PROJECT/LOCATION
OLDE WINCHESTER **BROOKLIN, ONT**

SITE GRADING PLAN

PROJECT No. 09014 LOT NUMBER

134

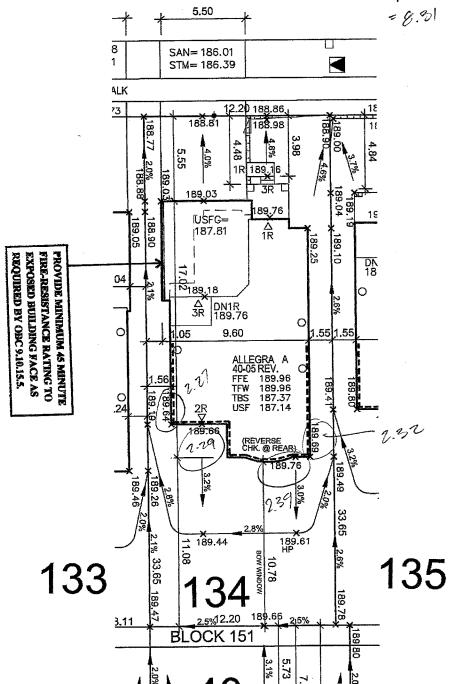
use sk-1 detail for FOUNDATION WALLS ON THIS LOT (SEE ATTACHED)

LOT GRADING PLANS APPROVED SUBJECT TO REVISIONS NOTED
